## Charlotte-Mecklenburg Planning Department

**SUBJECT:** Administrative Approval for Petition No. 2013-005 Charlotte Knights

**BB&T BALLPARK -  
UMUD-O REZONING**

SHEET TITLE  
**LANDSCAPE PLAN**

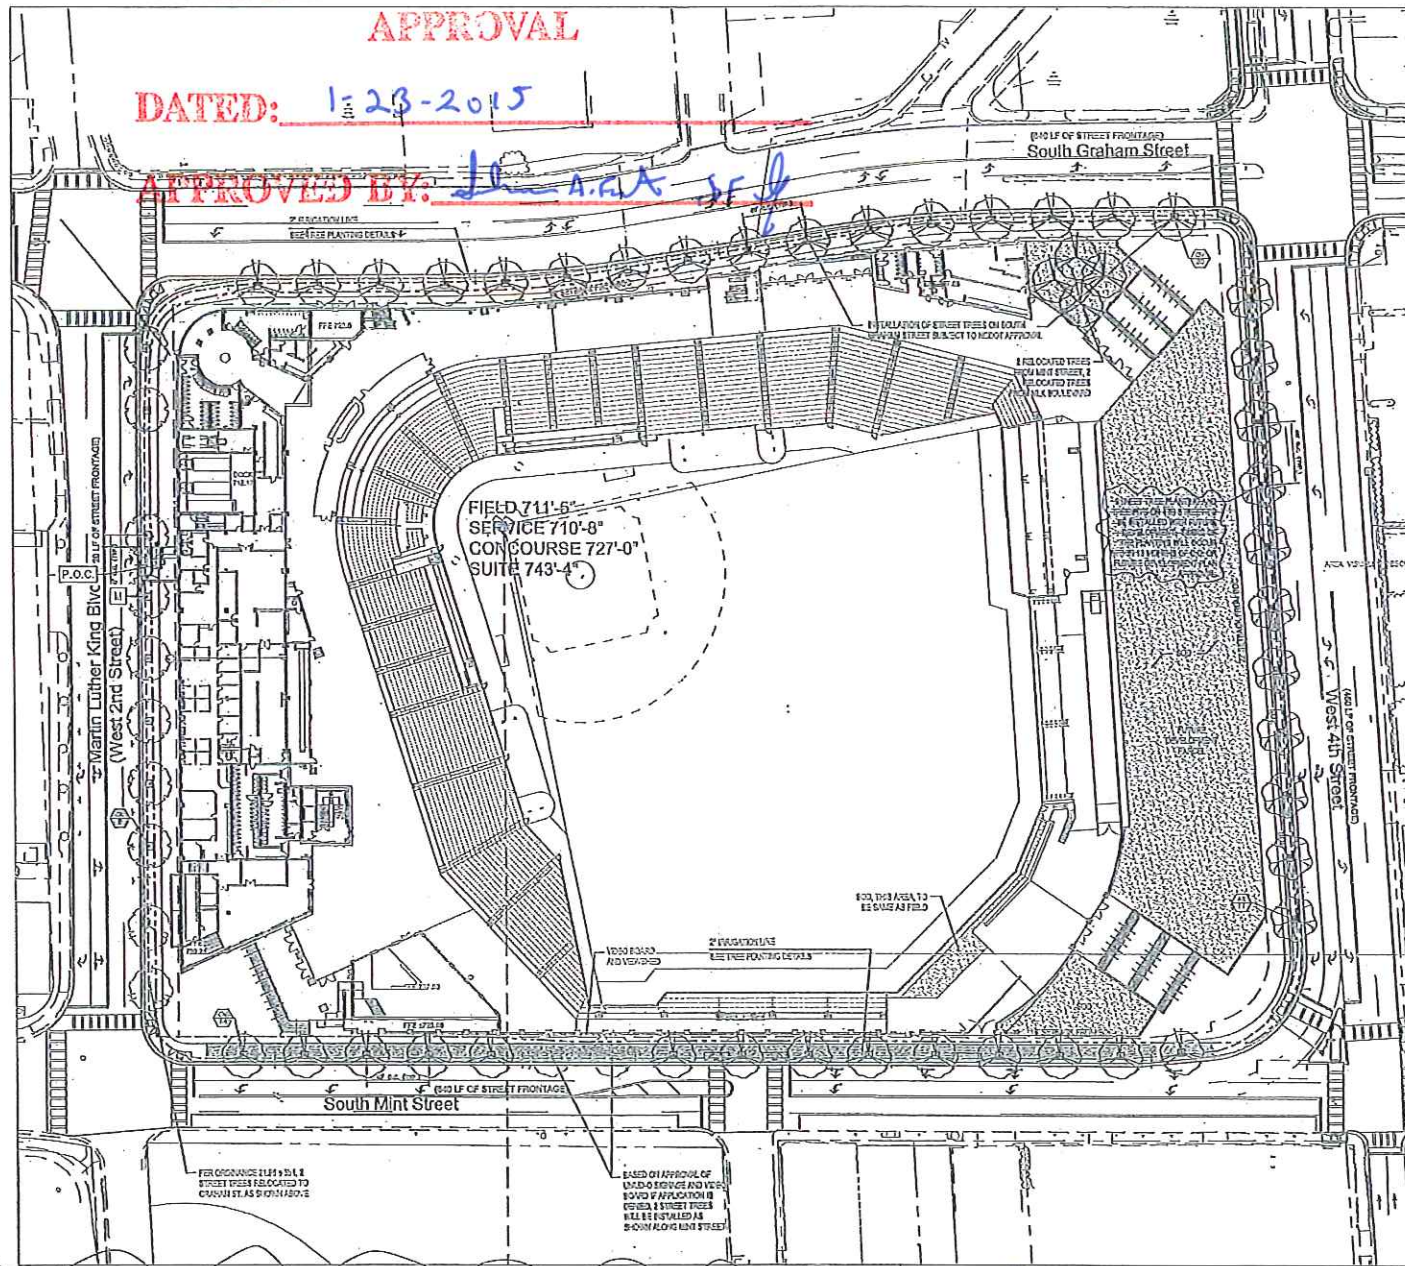
- Allow the installation of the required sidewalk, tree pits and trees along the property frontage on West Fourth Street to be delayed to October 31 2015. If permitting has been initiated for new development along the property frontage on West Fourth Street prior to October 31, 2015, defer the installation of the required sidewalk, tree pits and trees, to be installed as a requirement of that new development. If construction of such new development has not begun within 120 days of building permit approval, the required sidewalk, tree pits and trees shall have been installed.

- Allow a temporary sidewalk, 6 feet in width, adjacent to the curb, along the property frontage on West Fourth Street, until the required sidewalk, tree pits and trees are installed, or construction begins on new development along the frontage.

- Allow a temporary black vinyl coated chain link fence with gate along property frontage on West Fourth Street, placed at least 12 feet from the back of curb, to be removed when the permanent sidewalk is installed or construction begins for new development.
